October 2020  
FL862A  
NHTSA #20V-539  
Transport Canada #2020-419

## **Subject: Watson & Chalin Lift Axle Cap Screws**

**Models Affected: Specific Model Year 2020-2021 Freightliner 114SD, 122SD, and Western Star 4700, 4900 model vehicles, manufactured June 21, 2019, through August 6, 2020.**

**Fig. 1, Pivot Fastener Location, Driver Side View**

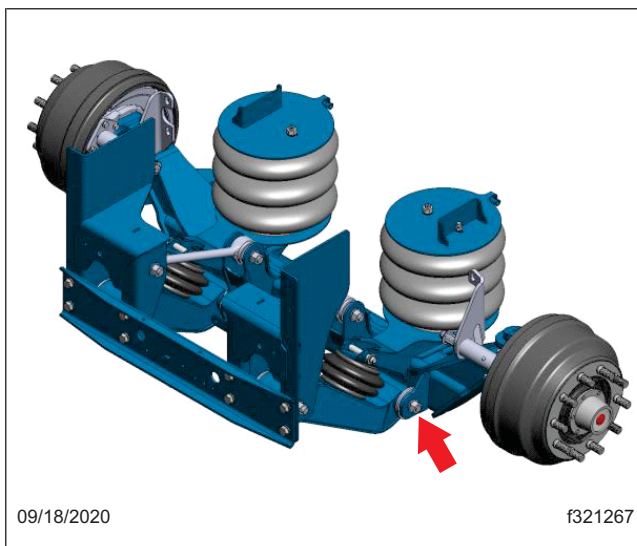
On certain vehicles, the steerable lift axle suspension system may be equipped with lower rear pivot capscrews that are not long enough to sufficiently engage the locking feature of the corresponding nuts. This condition can result in suspension damage, increased wear, and may result in the fracture or loss of the capscrews, related washers, and nuts. This can result in foreign object debris on the roadway, increasing the risk of a crash and/or injury.

The lower rear pivot capscrews and related hardware will be replaced with longer capscrews and new hardware.

- 8.3 Secure the control arm in place, and remove the capscrew using a punch and a hammer.
9. On the same side of the vehicle, install the replacement fasteners as follows, using the parts kit provided by Watson & Chalin.
  - 9.1 With the control arm secured in place, install the lower control arm spacer washers in the locations noted during removal.
  - 9.2 Install the lower control arm pivot capscrew, washers, and nut. Hand tighten the nut.

- 9.3 Secure the head of the capscrew with a combination wrench, and tighten the nut to 400 lb·ft (542 N·m) torque.
10. Repeat steps 8 and 9 on the other side of the vehicle.
11. Connect the batteries.
12. Connect the auxiliary lift axle air lines.
13. Clean a spot on the base label (Form WAR259), write recall number FL862 on a blank red completion sticker (Form WAR260), and attach it to the base label.
